Comprehensive Design Plan CDP-9403-H1

Hampton Subdivision Lot 40, Block H (Davis Sunroom)

STAFF REPORT

SUBJECT: Homeowner's Minor Amendment to a Comprehensive Design Plan CDP-9403-H1
Hampton Subdivision Lot 40, Bock H (Davis Sunroom)

SITE PLAN

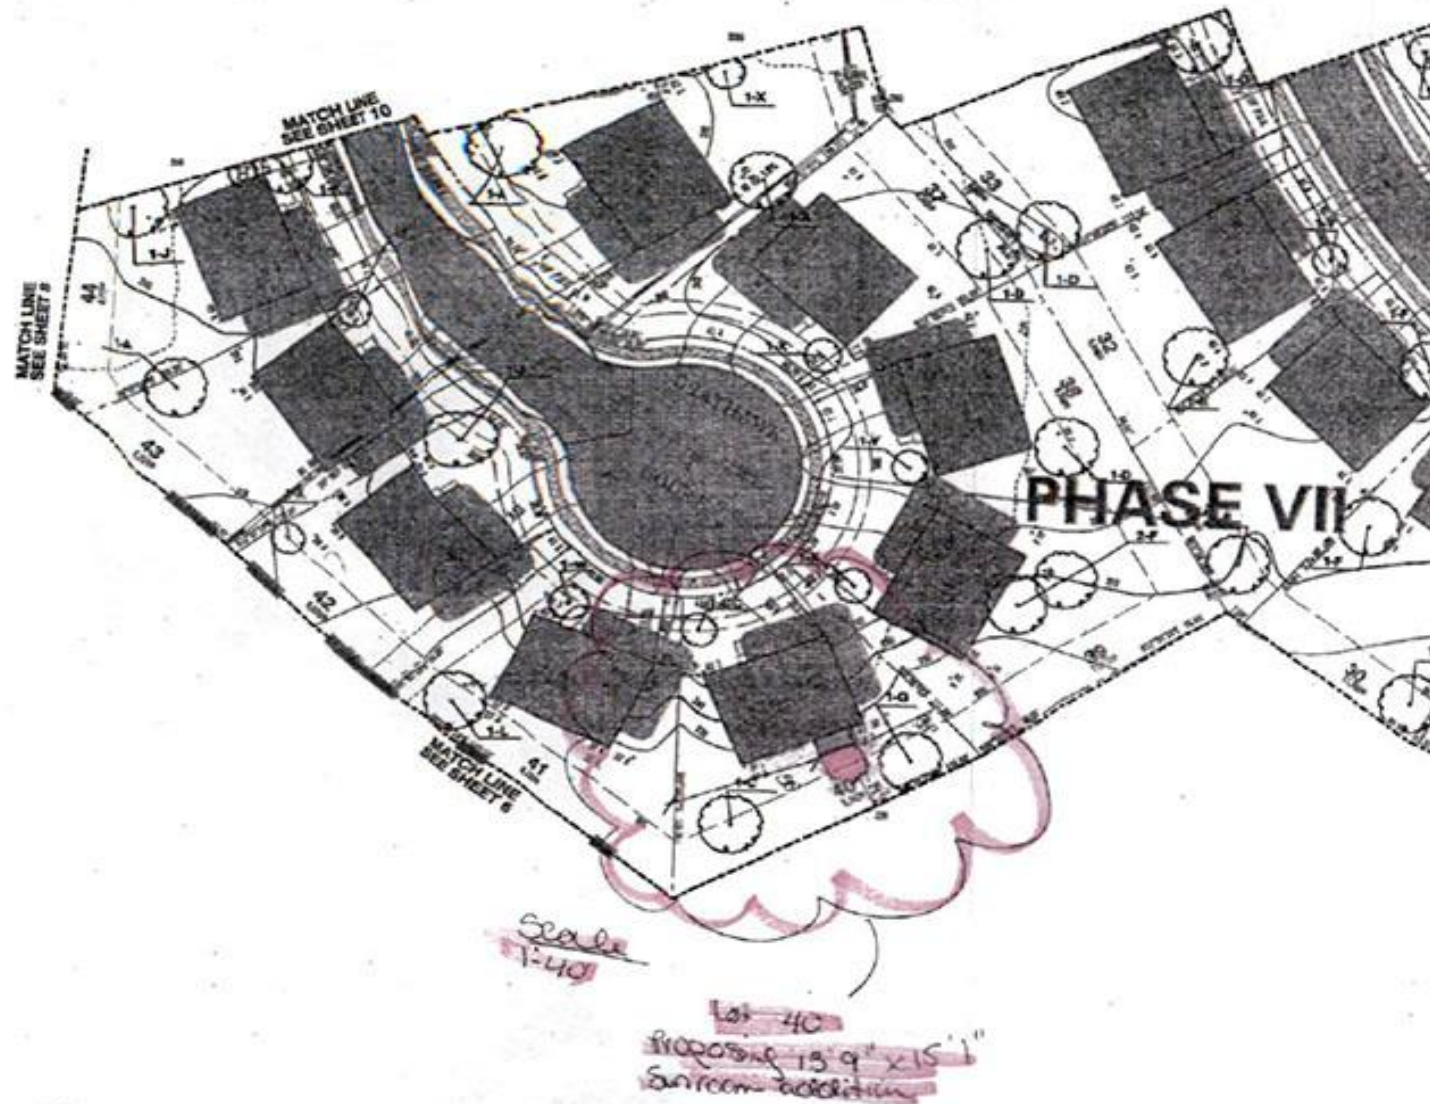
11. **Referral Comments:** The application was referred to the concerned agencies and divisions. Referral comments are summarized, as follows:
 - a. **Permit Review Section**—In a memorandum dated October 22, 2019 (Glascoe to Bossi), the Permit Review Section suggested that plans provided be more legible and detailed.

1. The plans that was submit need to be more legible there is a site plan which can be obtain in Dam's SDP-9910/08 pages 11 of 23SDP and 8 of 23SDP.
2. Also provide exhibit of the purposed Deck which need to include Setback and Distance of dwelling to each property line and Bearings and distances that match record plat.
